PERMANENTE CREEK LONG-TERM RESTORATION PLAN

**Re: Response to Board Comments Letter (dated 11/12/09) [CIWQ Place ID:
234559 (bkw)]
CAO No. 99-018 – Permanente Creek Long-Term Restoration Plan
Lehigh Southwest Cement Company, Cupertino, California**

Response to Board Comments of November 12, 2009
 Permanente Creek Long-Term Restoration Plan
 Lehigh Southwest Cement Company, Cupertino, California

Comments on Permanente Creek Long-Term Restoration Plan (Nov. 12, 2009, CAO 99-018)

URS Corp - Oakland CA - S. Loria
 L:\Projects\Permanente Creek Restoration Plan_v3.mxd - 3/4/2010 @ 4:24:52 PM

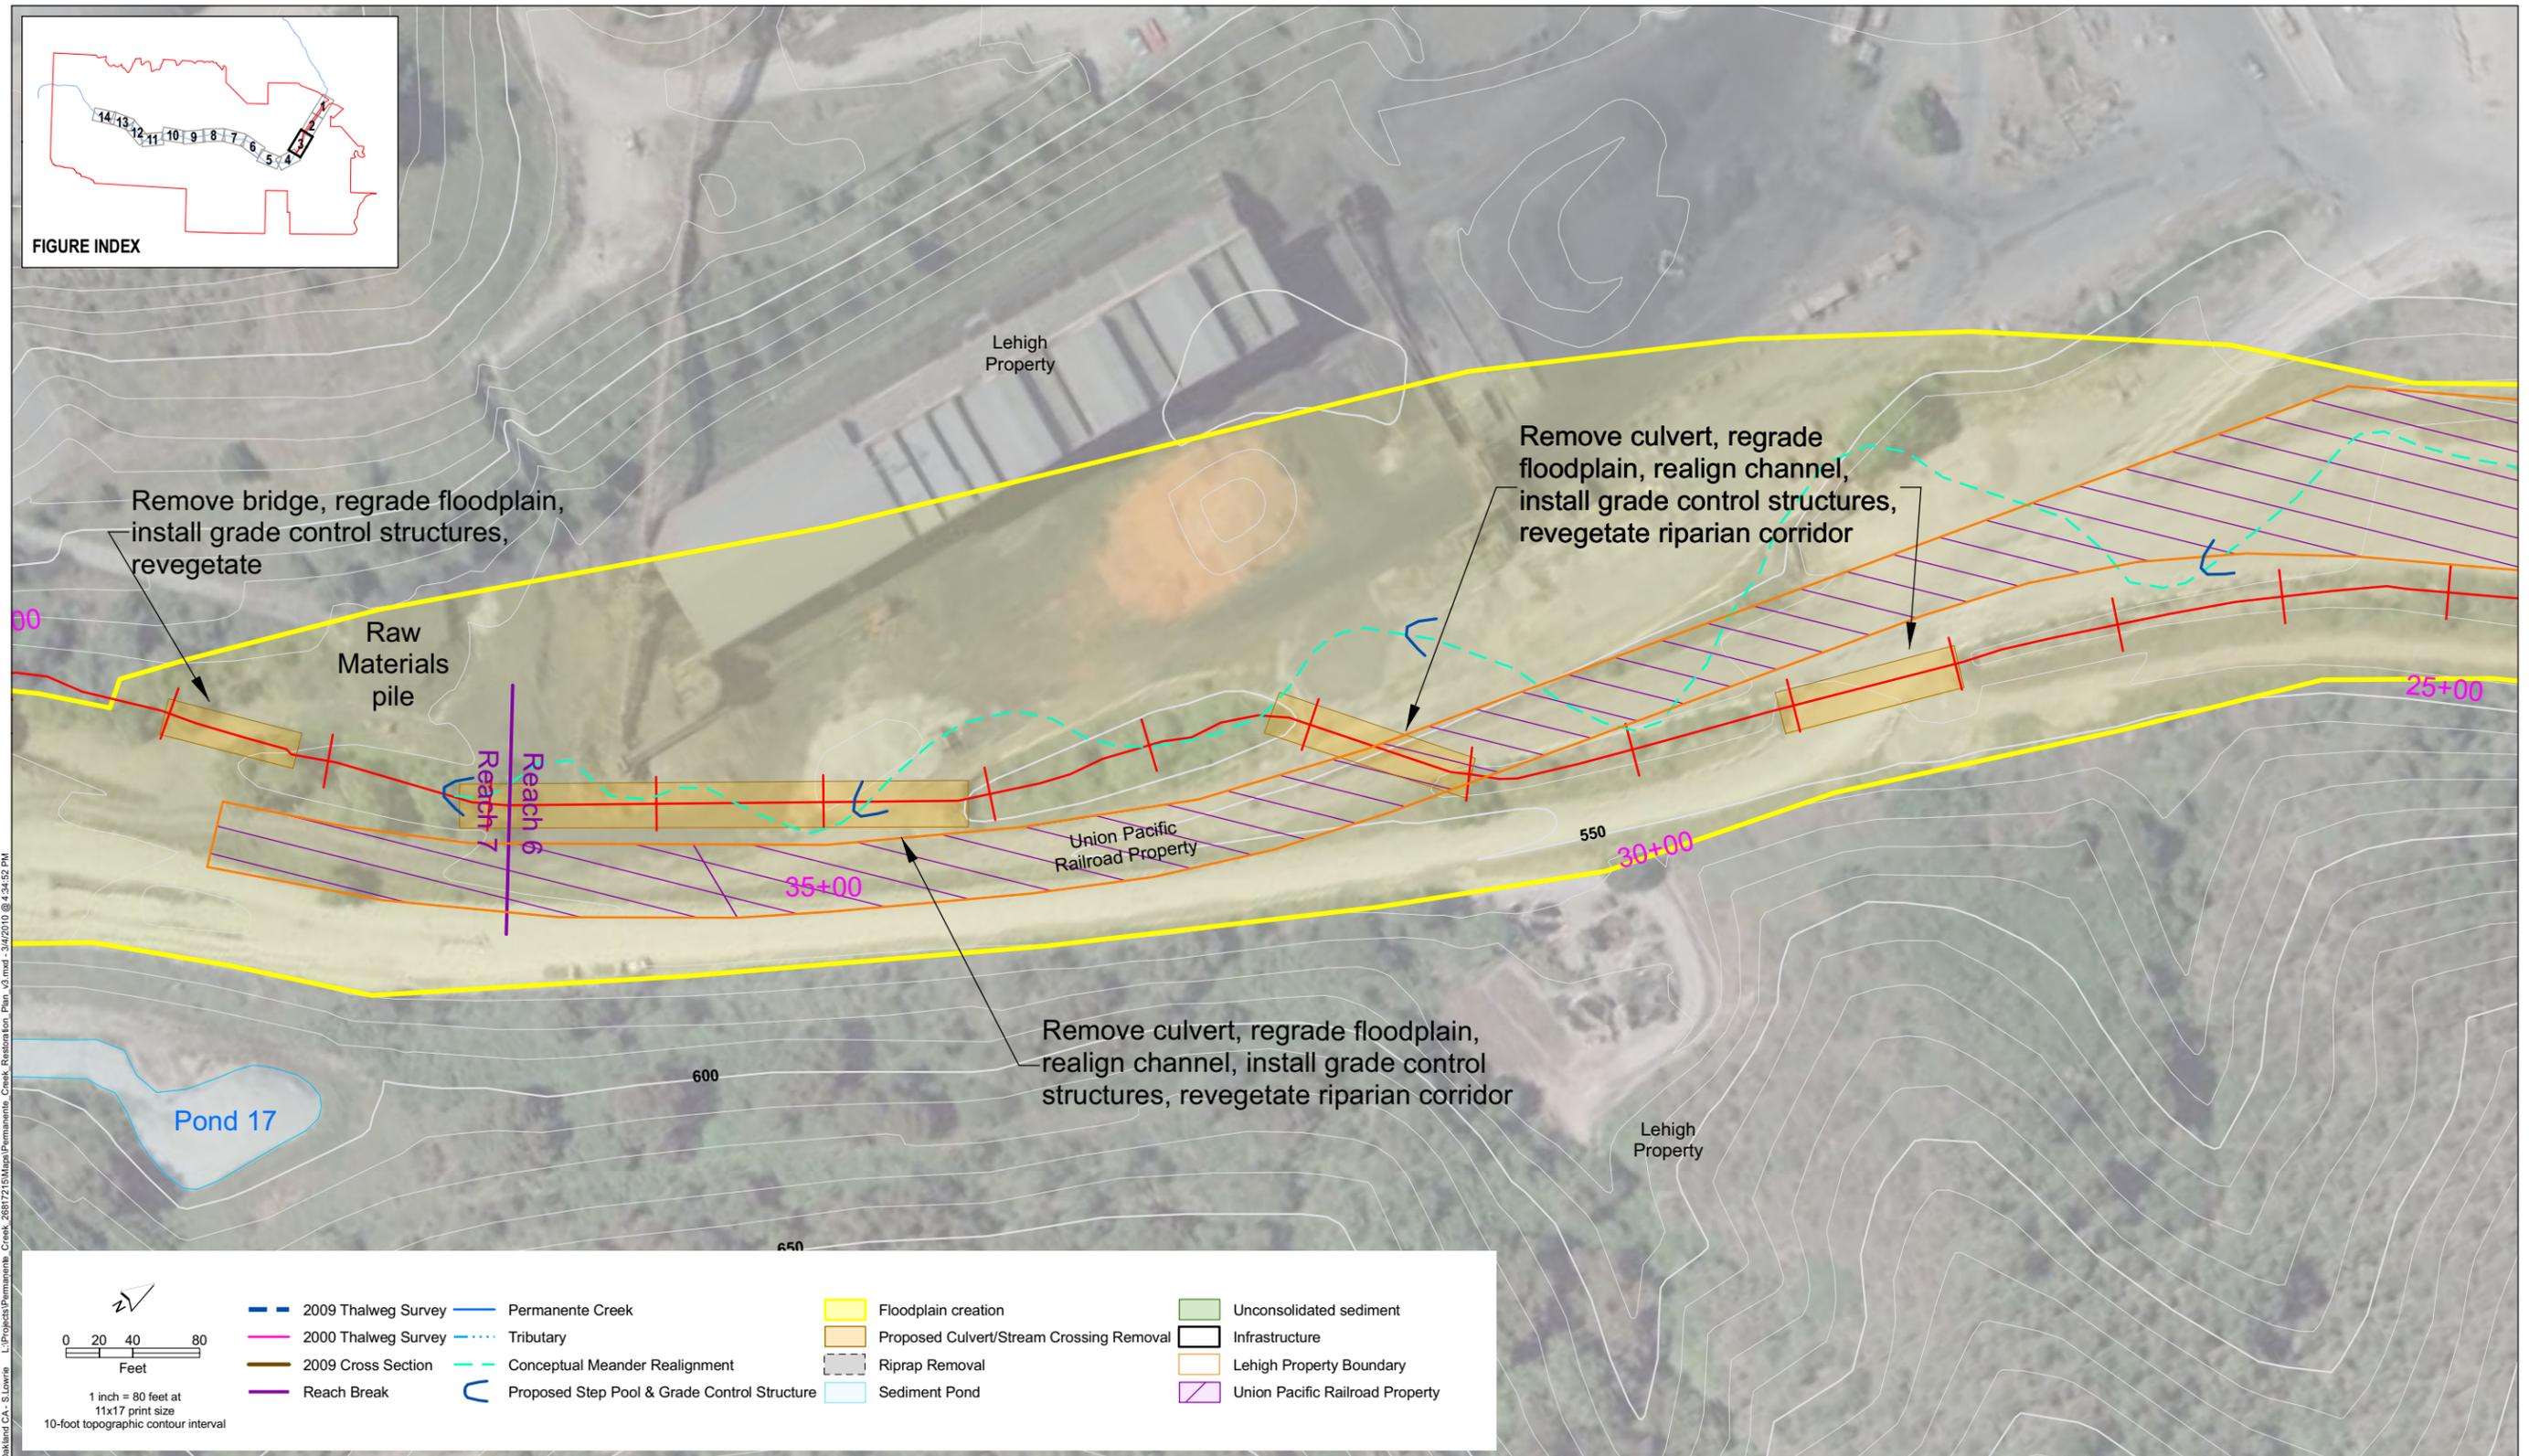
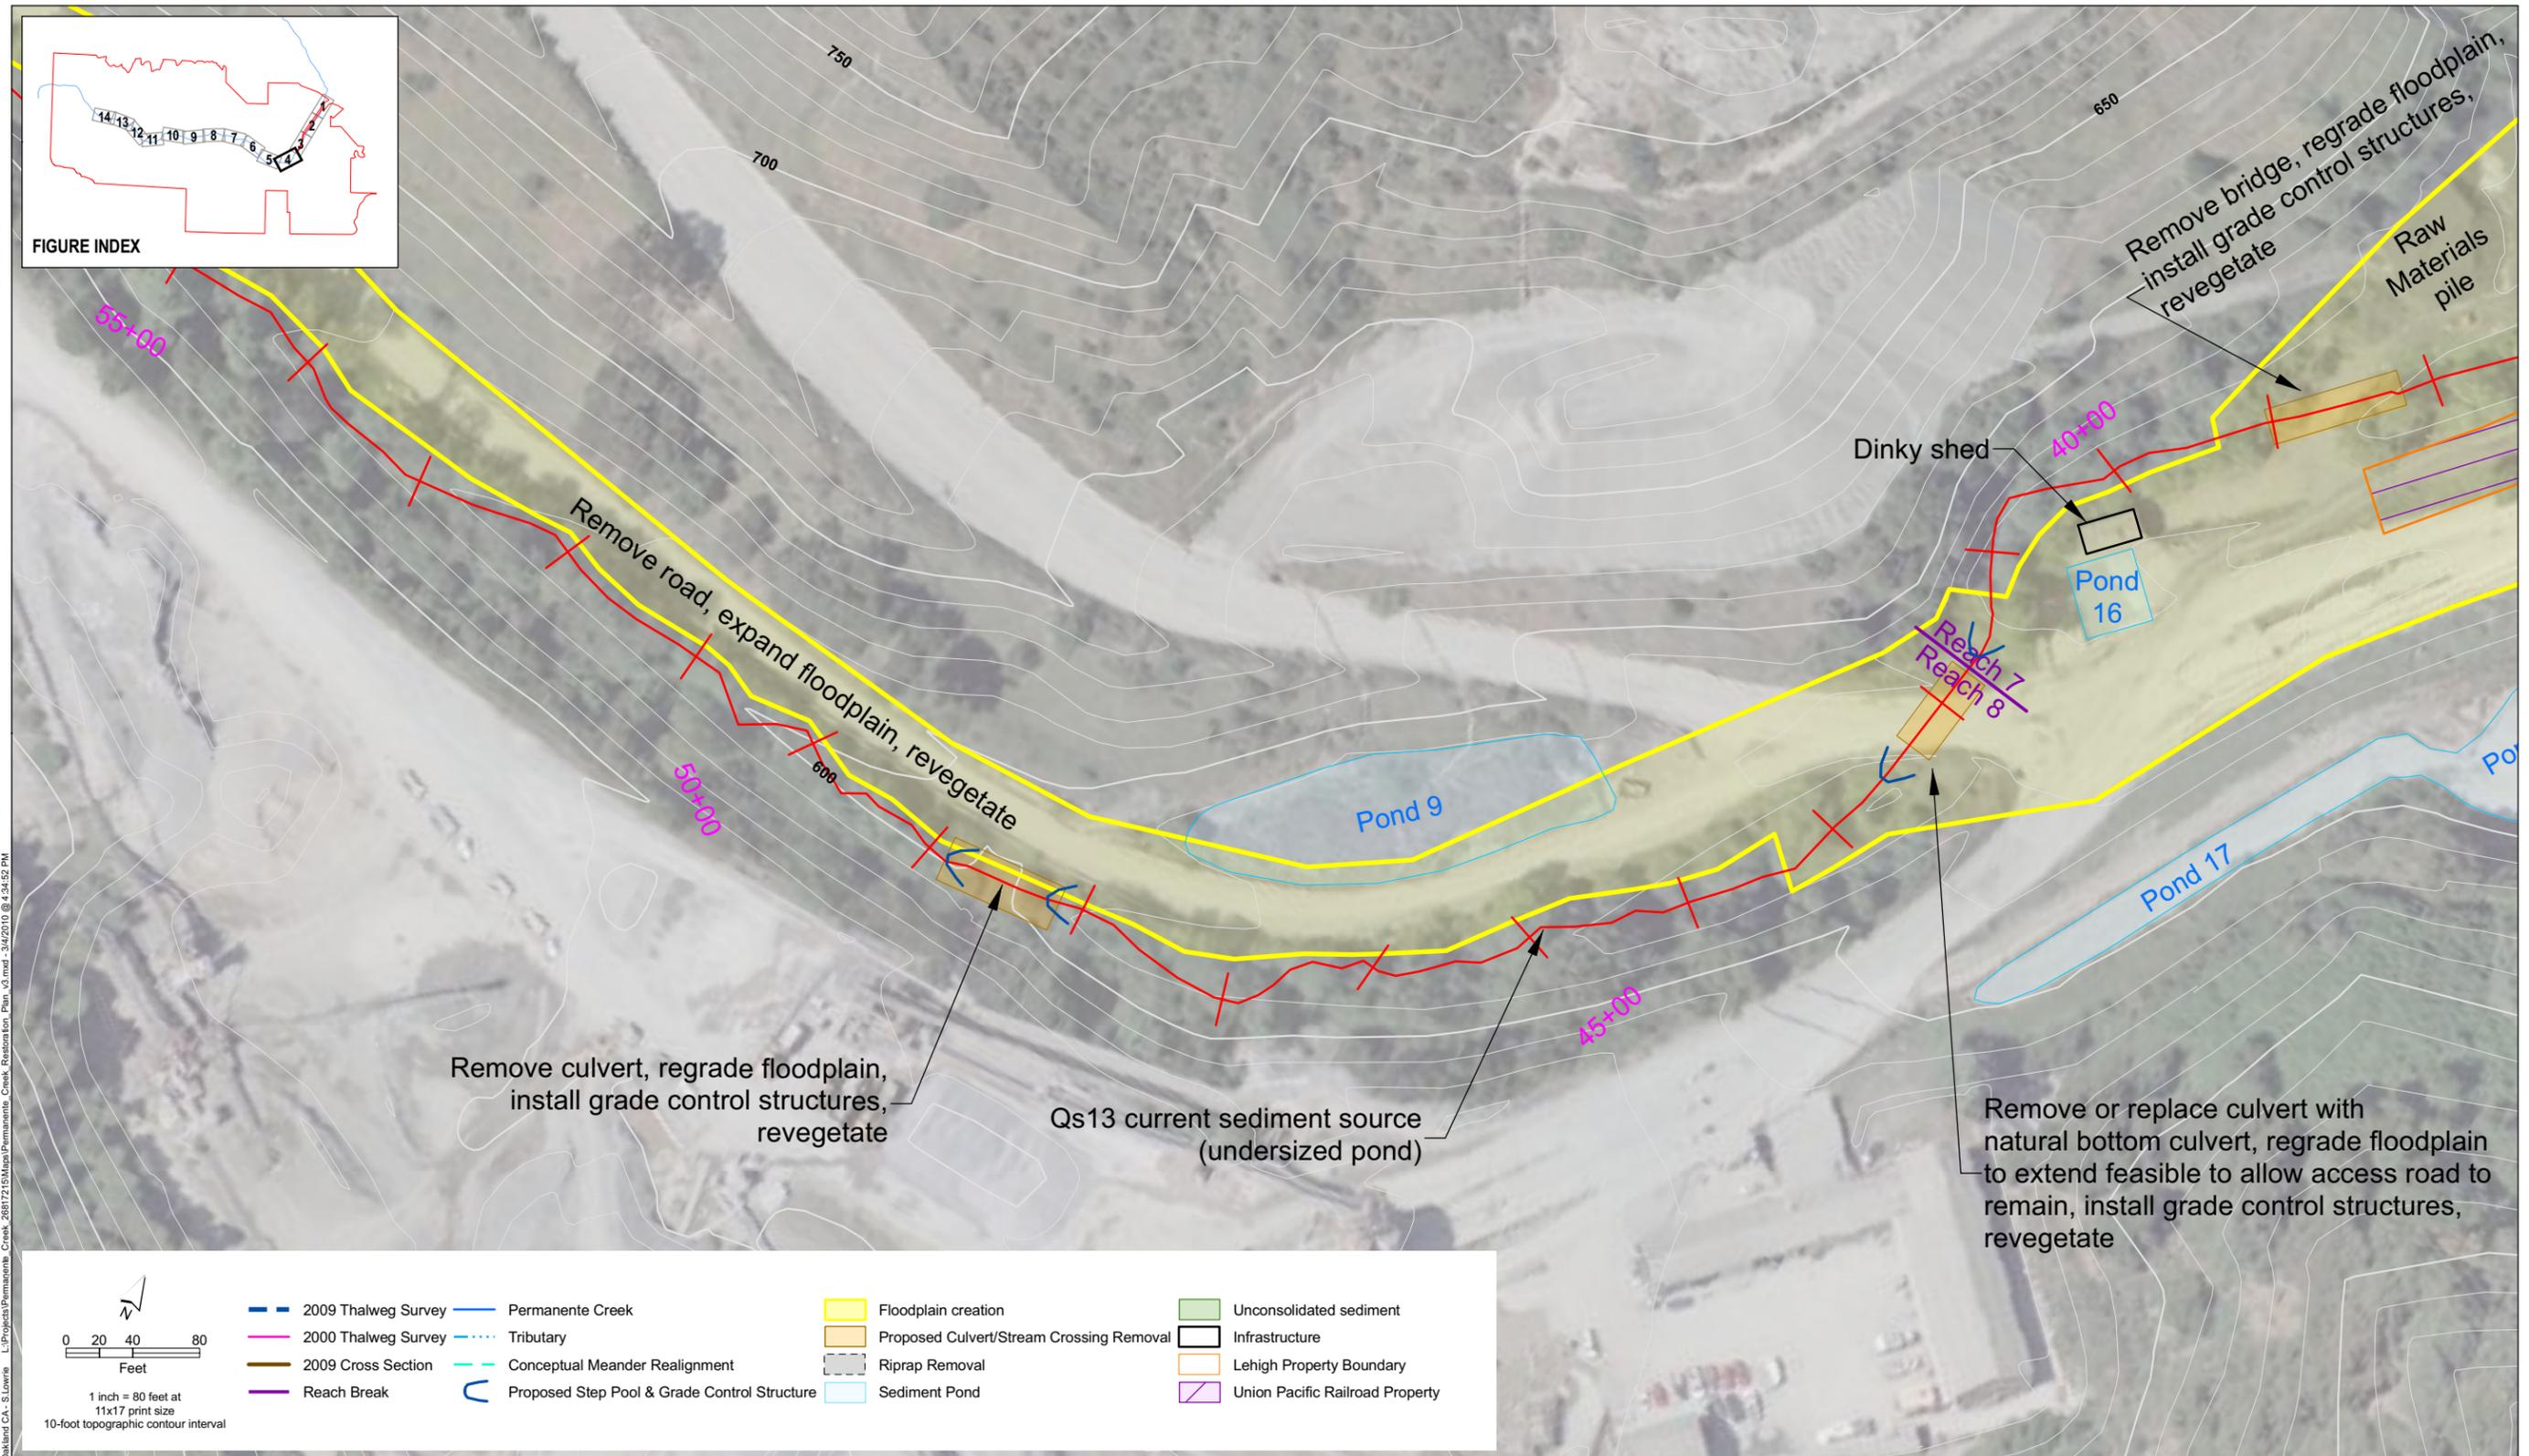
Specific Comment	Document Page	Section	Topic
27	NA	Appendix A	(Figure 1-3)
Comment Text			
The 14 annotated aerial photographs in Figures 1-3.1 through 1-3.14 indicate several significant features (e.g., culverts, ponds). It is not clear if these figures include all in-channel features, or just the in-channel features proposed for removal or modification in the Restoration Plan. Please make sure that all in-channel features are included so that it is easier for Water Board staff to determine if further restoration activities should be assessed for inclusion in the Restoration Plan.			
Comment Response			
The features depicted in Figure 1-3 include all in-channel infrastructure, not just that proposed for removal.

Comment Response			
<p>A new reference system has been simplified. The revised Long-Term Restoration Plan includes cross referencing of the 14 aerial photographs in Appendix A with a new reach designation system. The location nomenclature formerly used in the previous draft, [A] through [R], is no longer used. Please see Table 4-2 and Figure 1-3, where these changes have been implemented. In addition, a new appendix (Appendix B) has been added that correlates the reach nomenclature from the Phase I Report with that of the revised Plan.</p>
